Subdivision Authority

File No. LDA10-0398

RE: Tentative plan of subdivision to create 26 semi-detached and 30 row housing residential lots from a portion of the north half of SW 5-52-23-4, located east of 17 Street NW and north of 23 Avenue NW; **TAMARACK**

SUBDIVISION CONDITIONS OF APPROVAL MAP

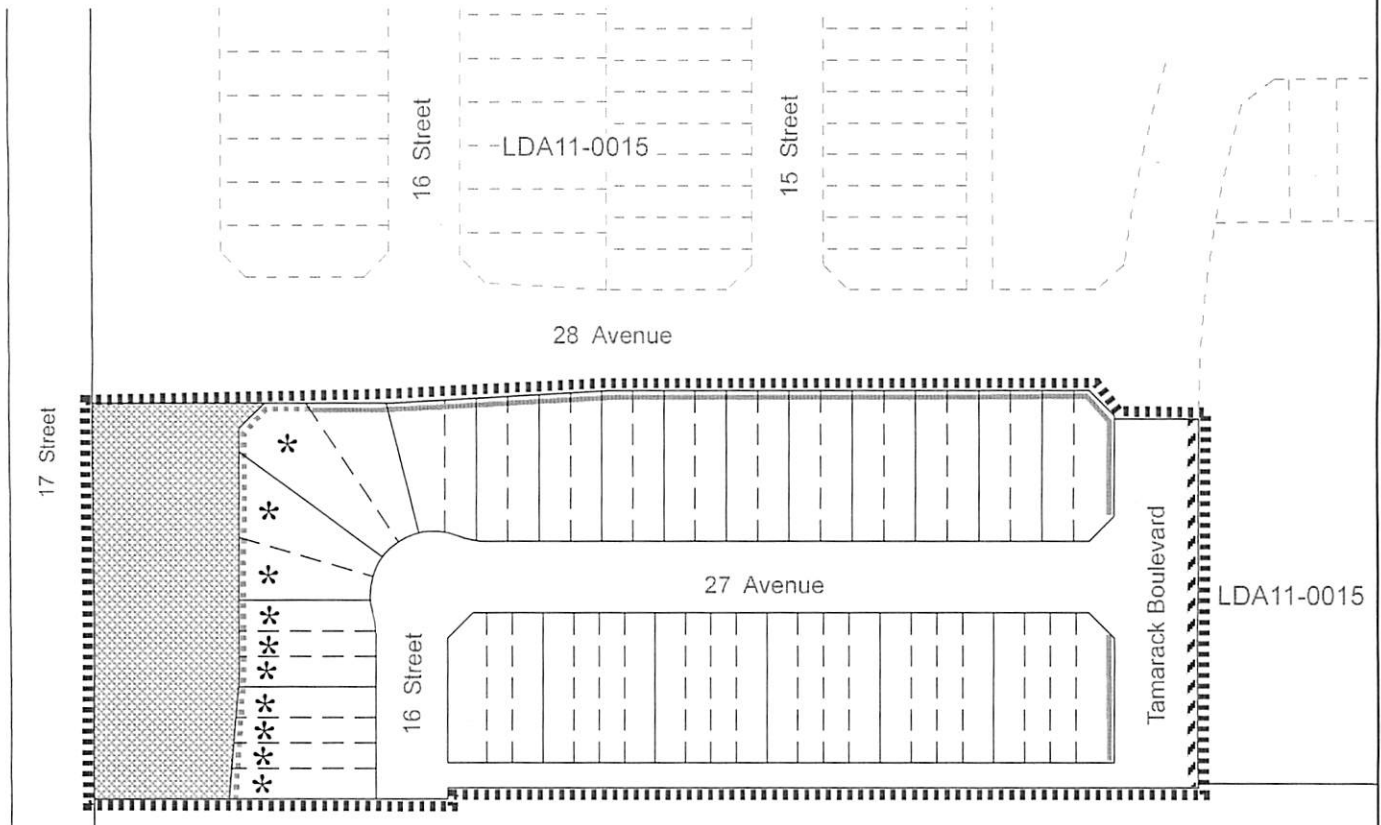
3. that approved subdivision within the Tamarack Neighbourhood (File No. LDA11-0015) be registered prior to or concurrent with this application;
4. that the owner prepare a restrictive covenant in favour of the City of Edmonton that will be registered on all lots backing onto 17 Street to protect the integrity of the berm and fence, as shown on the "Conditions of Approval" map, Enclosure I;

5. that the owner dedicate 17 Street NW in conformance with the approved Concept Plan or to the satisfaction of Transportation Services, as shown on the "Conditions of Approval" map, Enclosure I;

6. that subject to Clause I (5), the owner clear and level 17 Street NW as required for road right-of-way dedication to the satisfaction of Transportation Services; and

7. that a noise study be provided to confirm the noise attenuation required adjacent to 17 Street NW, in accordance with the City of Edmonton's Urban Traffic Noise Policy, and to the satisfaction of Transportation Services and that the owner construct noise attenuation in accordance with the requirements outlined in a Noise Study. At minimum, a 1 m berm and a 1.8 m noise attenuation fence will be required as per the City of Edmonton Roadway Design and Construction Standards Drawing No. 5205, or combination thereof, within residential property lines for all lots adjacent to 17 Street, as shown on the "Conditions of Approval" map, Enclosure I, to the satisfaction of Transportation Services;

9. that the owner construct all fences (wholly within private lands), bollards, lighting, shared use paths, and sidewalks, to the satisfaction of the Transportation Services and Sustainable Development in the locations identified on the "Conditions of Approval Map", Enclosure I; and
